Staff Report  Zoning & Land Regulation Committee	<u>Public Hearing:</u> April 22, 2025	Petition 12133
	<u>Zoning Amendment Requested:</u> AT-35 Agriculture Transition District TO RR-4 Rural Residential District	<u>Town, Section:</u> SPRINGDALE, Section 17
	<u>Size:</u> 8 Acres	<u>Survey Required:</u> Yes
	<u>Reason for the request:</u> Creating two residential lots	
		<u>Address:</u> EAST OF 9204 GEM VIEW ROAD

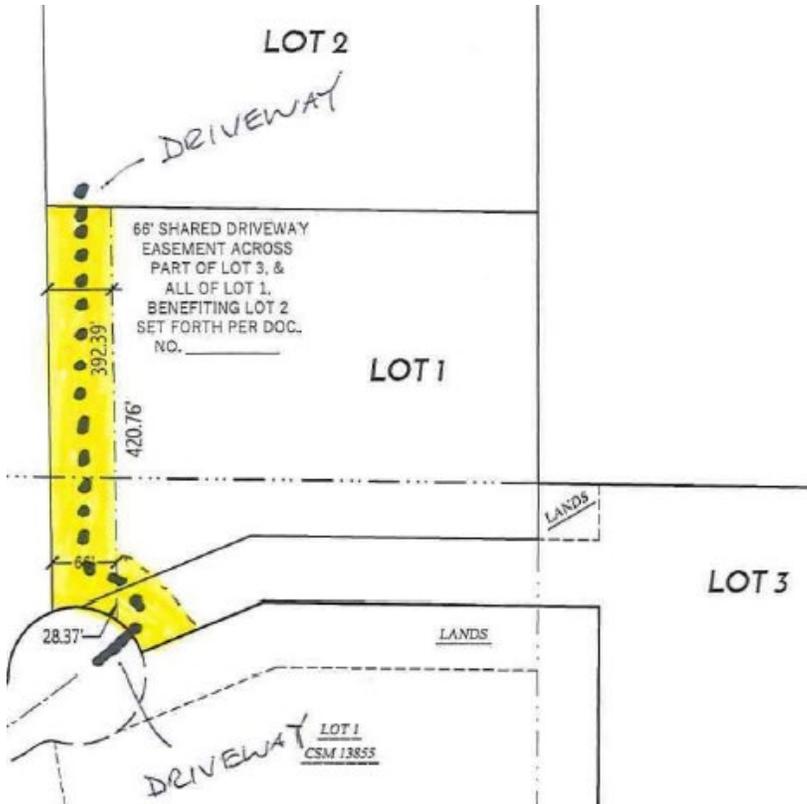
OBSERVATIONS: The lots meet most county ordinance requirements for lot size and configuration. The proposal would provide the required 66 feet of lot width and road frontage on the agricultural Lot 4. It would provide access to Lot 2 (which has no road frontage) by a shared access easement across both Lot 1 and Lot 3. In order to have a lot without frontage, the adjacent lot must have a 66-foot wide driveway easement and the agreement must meet specific requirements under Dane County Land Division Ordinance Section 75.19(8). This was discussed with the applicants previously and options were provided to meet ordinance requirements.

Because Lot 1 (where the driveway would be located) does not have 66 feet of road frontage, the CSM will need to be adjusted to either (a) expand the access easement on Lot 3 to include that lot's entire 66 feet of frontage, and locate the driveway entrance within Lot 3 or (b) modify Lot 1 so that it has 66 feet of frontage (this would require reducing Lot 3's frontage; a minimum 30 feet of frontage is required in this case).

STAFF RECOMMENDATION: As noted above, there are a couple of ways the applicants can address the lot layout and driveway access requirements of the Dane County Chapter 75 land division ordinance. Lots 1 and 3 could be reconfigured slightly so that the entire access easement is on Lot 1. Alternately, if the lot layout remains as proposed, another workable solution would be to expand the easement and construct the driveway as shown below:

1. The layout of the lots shall meet the Shared Access easement requirements in s.75.19(8) of Dane County Land Division Ordinance.
